JDSU 211x Remote Interface	
Kevin Cricqui	kevin@junktronix.com
Rev 0.1	Page 1 of 1
5/31/2003

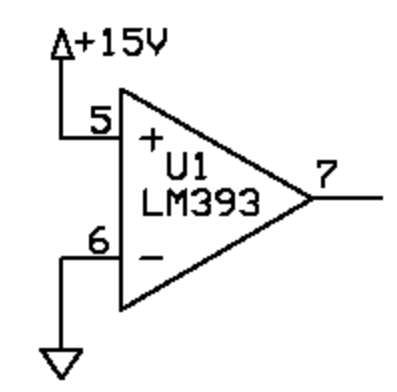
NOTES
 R5 TO BE ADJUSTED FOR 10:1 DIVIDE
 ADJUST R6 SO THAT U1-3 IS 0.5V
 FIXED SWAP OF PINS 8 AND 9 - Sam
